EY AIRCRAFT, INC.
KERRVILLE, TEXAS

SERVICE LETTER 20-13

SUBJECT: Kit Turn & Bank Indicator Mounting Spacer.

MODELS AFFECTED: 1002 Thru 1043

Figure 1.

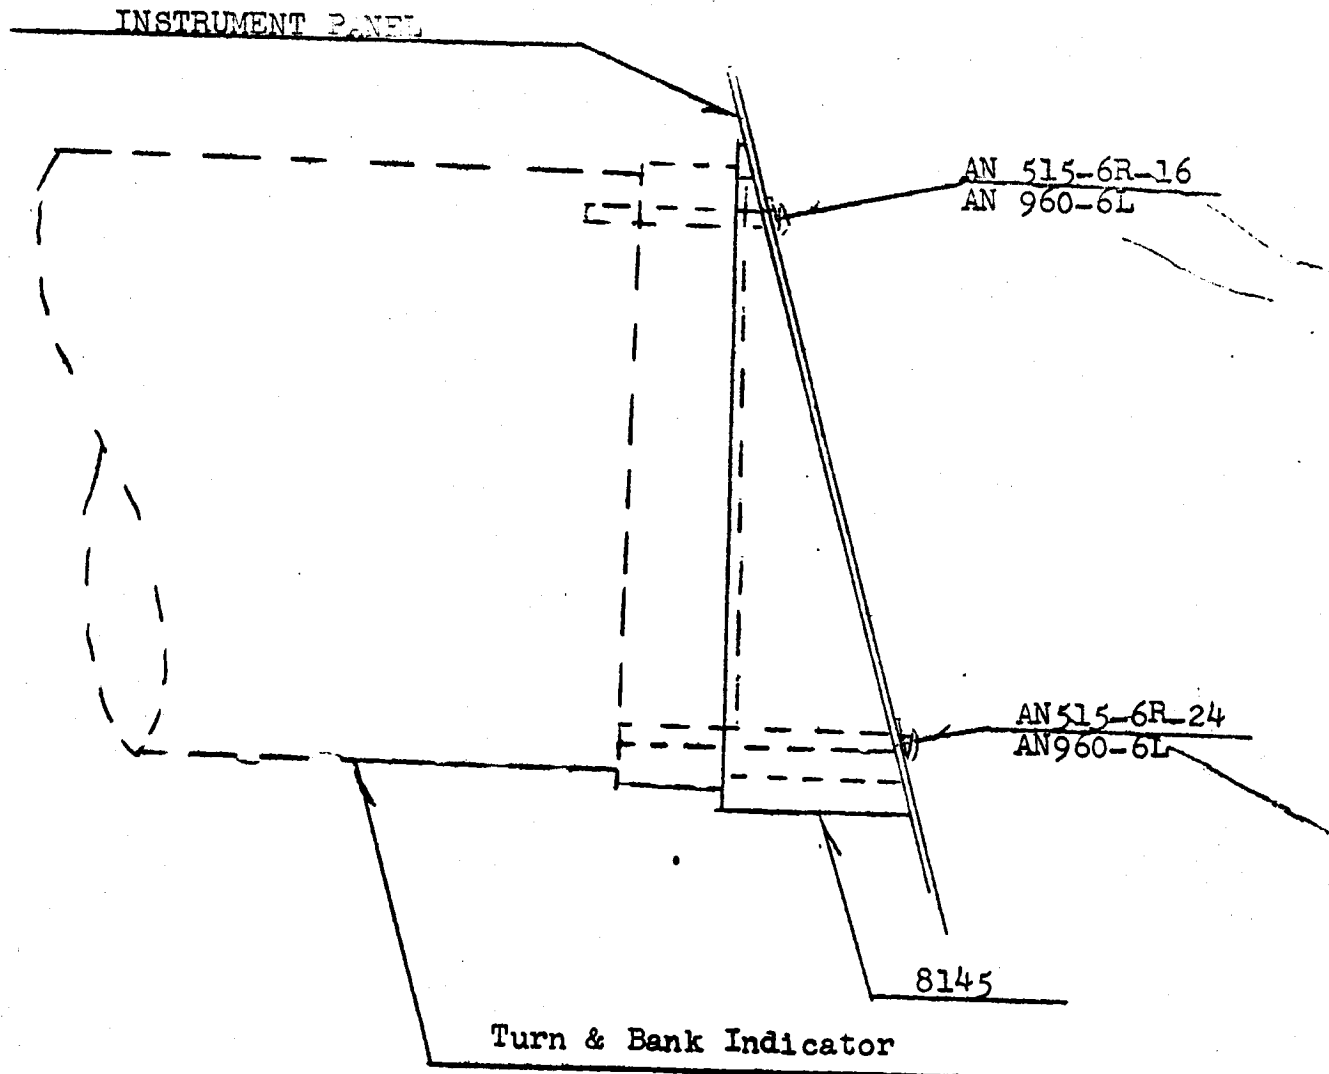
In several cases the turn and bank indicator on the M-20 has been replaced because it was not working properly. This is probably due to the fact that it is not mounted parallel to the line of thrust. In an attempt to correct this situation, a spacer is now being installed on production models. This kit is enclosed without charge for installation on units in the field as shown in figure one.

PARTS LIST: 8145 (1)
AN515-6R-16(1)
AN515-6R-24(1)
AN960-6L (2)
